**SUBDIVISION & PLANNED UNIT
DEVELOPMENT STAFF REPORT****Date: August 18, 2016**

<u>NAME</u>	Liberty Motors
<u>SUBDIVISION NAME</u>	Liberty Motors Subdivision
<u>LOCATION</u>	414 & 430 Schillinger Road North (East side of Schillinger Road North, 520'± North of 7 th Avenue).
<u>CITY COUNCIL DISTRICT</u>	District 7
<u>PRESENT ZONING</u>	B-3, Community Business District
<u>AREA OF PROPERTY</u>	3.3± Acre
<u>CONTEMPLATED USE</u>	Subdivision approval to create one legal lot of record; and Planned Unit Development to allow multiple buildings on a single building site.
<u>TIME SCHEDULE FOR DEVELOPMENT</u>	Not Specified
<u>ENGINEERING COMMENTS</u>

SITE PLAN

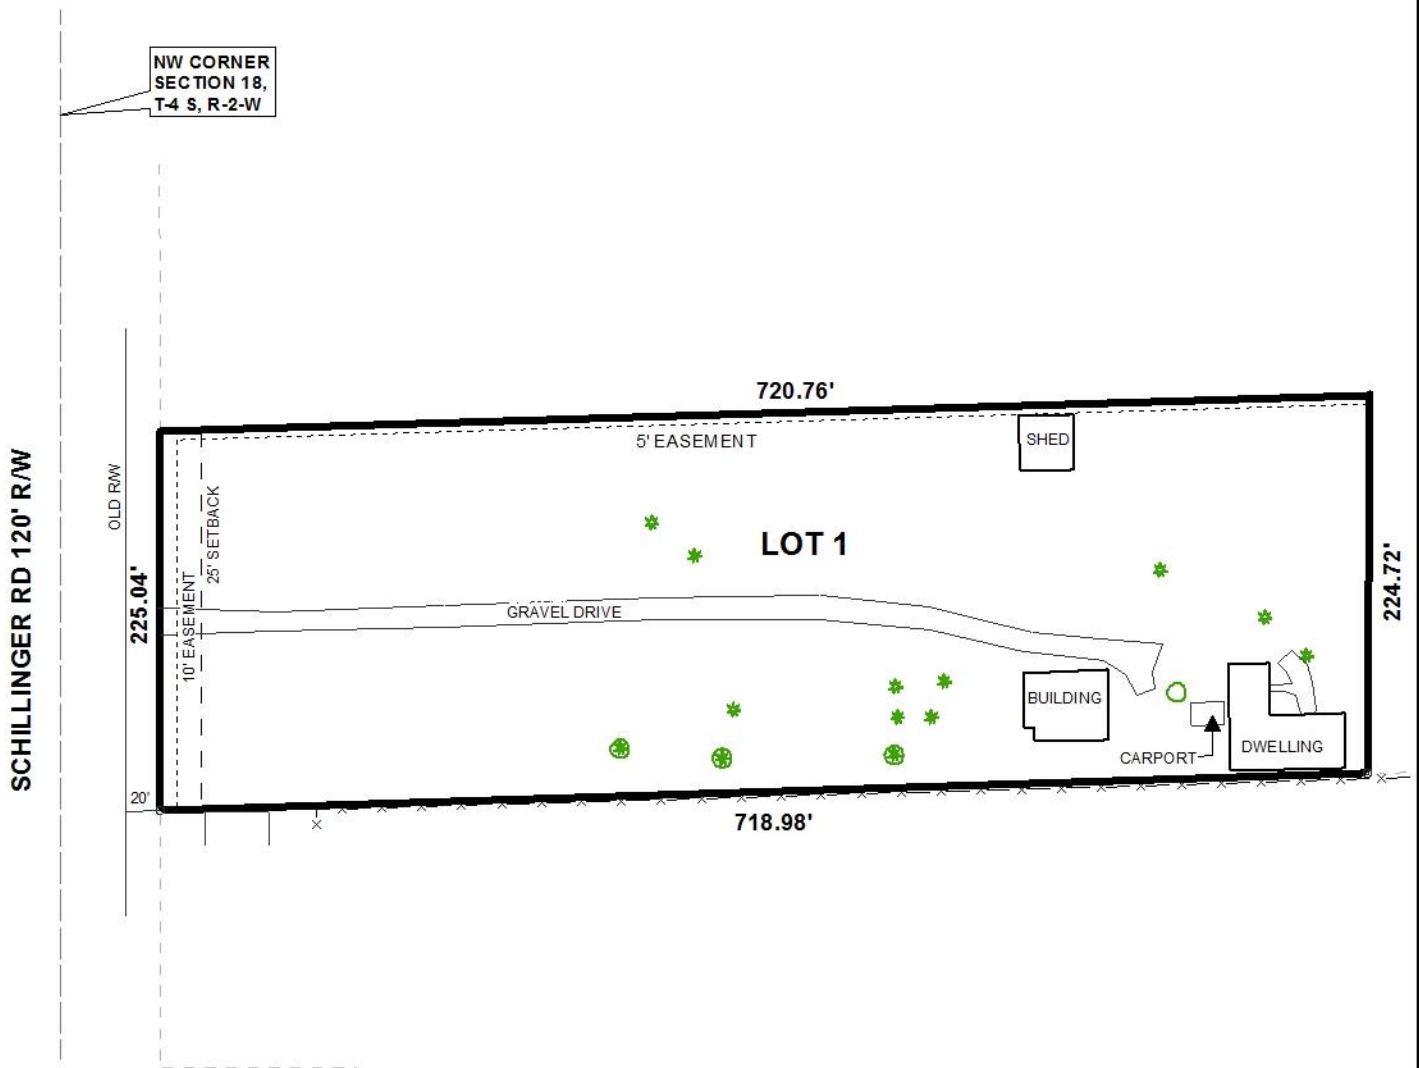
Although a portion of the existing site is to remain undisturbed, the entire site, including all proposed and existing improvements, should be shown on the site plan that depicts proposed improvements. Furthermore, the use of the other structures that will remain on the rear portion of the site should be provided as part of the application, as any commercial use of these structures may require Building and Fire Code compliance, whereas residential use of the structures may impose other requirements on the site.

The *Site Data* information on the site plan states that the rear yard setback is 122' from the project site area; however, this cannot be appropriately determined due to the entire subject site not being illustrated on the site plan. The "master site plan" that is included on the site plan indicates that the rear of the proposed project site measures approximately 119' to the rear yard property line of the entire subject site, but it does not depict all proposed and existing site improvements. As PUD approvals are site plan specific, the site plan should be revised to illustrate the entire site with all proposed and existing improvements.

The proposed development appears to be compliant as it relates to site coverage; however, the site plan should be revised to illustrate compliant landscaping, tree, and parking calculations as required by Section 64-4.E of the Zoning Ordinance. The site plan does not indicate the total site

area in square feet on the illustration or in the *Site Data* information. Also, the frontage and perimeter tree planting calculations are missing for the entire site in the *Site Data* information as well. Furthermore, while the site plan illustrates trees being provided, it does not indicate, via a note or in the legend, which proposed trees are overstory or understory trees, or the species of each tree. It appears that more trees are required for this site than what is being proposed; thus, the site plan should be revised to indicate compliant landscaping, tree, and parking calculations for the entire site.

The site plan illustrates that 10 parking spaces will be provided to accommodate the proposed 12' x 56' office building on the subject property. According to Section 64-6 of the Zoning Ordinance, only 2 parking spaces are required for this site. The applicant is providing 8 more parking spaces than required; thus, exceeding the requirements of the Zoning Ordinance. The parking space stalls must ensure that wheel stops or curbing are provided in order to prevent encroachment into landscaped areas, sidewalks, and buildings. It should be noted that the parking area must also provide lighting in compliance with Section 64-6.A.3 of the Zoning Ordinance at time of permitting.

The parking space dimensions, access widths, as well as the drive aisle widths to the East, South, and West of the subject property appear to reflect Zoning Ordinance compliance; however, the drive aisle located on the North side of the property, in addition to the *Auto Display* aisles, are only depicted as 20' in width. The site plan should be revised to depict 24' aisle widths to accommodate two-way traffic for all proposed drives.

The front setback line is depicted as 10' on the site plan; however the Zoning Ordinance requires a distance of not less than 25' from the front property line in B-3 zoned districts. The site plan should be revised to depict a minimum building setback line distance of 25' in order to reflect compliance with the Zoning Ordinance and match the preliminary plat.

The location and dimensions of the proposed HVAC mechanical equipment for the proposed one-story office building structure is not illustrated on the site plan. The site plan should be revised to indicate the location, height and size of the HVAC mechanical equipment in compliance with Section 64-4.D.11 of the Zoning Ordinance.

The site plan does not indicate the method of garbage collection for the subject site. The site plan should be revised to illustrate that onsite garbage collection will be served via a dumpster with a connection to sanitary sewer in accordance with Section 64-4.D.9 of the Zoning Ordinance or the placement of a note on the site plan indicating such. Or, a note should be placed on the site plan stating that garbage collection will be provided via curbside or by private garbage collection services if a dumpster will not be provided.

A sidewalk is not depicted and labeled along the property's frontage on the site plan. If a sidewalk is not being proposed within the development of this site then a sidewalk waiver must be obtained, or a sidewalk must be provided and be clearly indicated on the site plan.

- 1) Revision of the site plan to depict the entirety of the site, and to provide use and size information regarding all existing structures that will remain on the rear portion of the site;

- 2) Revision of the *Site Data* information on the site plan to indicate the zoning district as B-3 and not as B-2;
- 3) Provision of a written statement to indicate the timeline for construction and the use of all structures on site;

- 4) Revision of the site plan to illustrate compliant landscaping, tree, and parking calculations for the entire site as required by Section 64-4.E of the Zoning Ordinance;

- 5) Revision of the site plan to illustrate curbing or bumper stops for each parking space abutting landscaped areas and buildings;
- 6) Revision of the site plan to indicate lighting within the parking area will be in compliance with Sections 64-6.A.3 and 64-6A.8. of the Zoning Ordinance;

- 7) Revision of the site plan to depict 24' aisle widths for all proposed drives;
- 8) Revision of the site plan to illustrate the front 25' minimum building set back line;

- 9) Revision of the site plan to illustrate that on site garbage collection will be served via a dumpster with a connection to sanitary sewer and compliant enclosure or placement of a note, or by private collection services in accordance with Section 64-4.D.9 of the Zoning Ordinance; and

- 10) Revision of the site plan to include a sidewalk along the entire frontage or the application for a sidewalk waiver if a sidewalk is not planned.
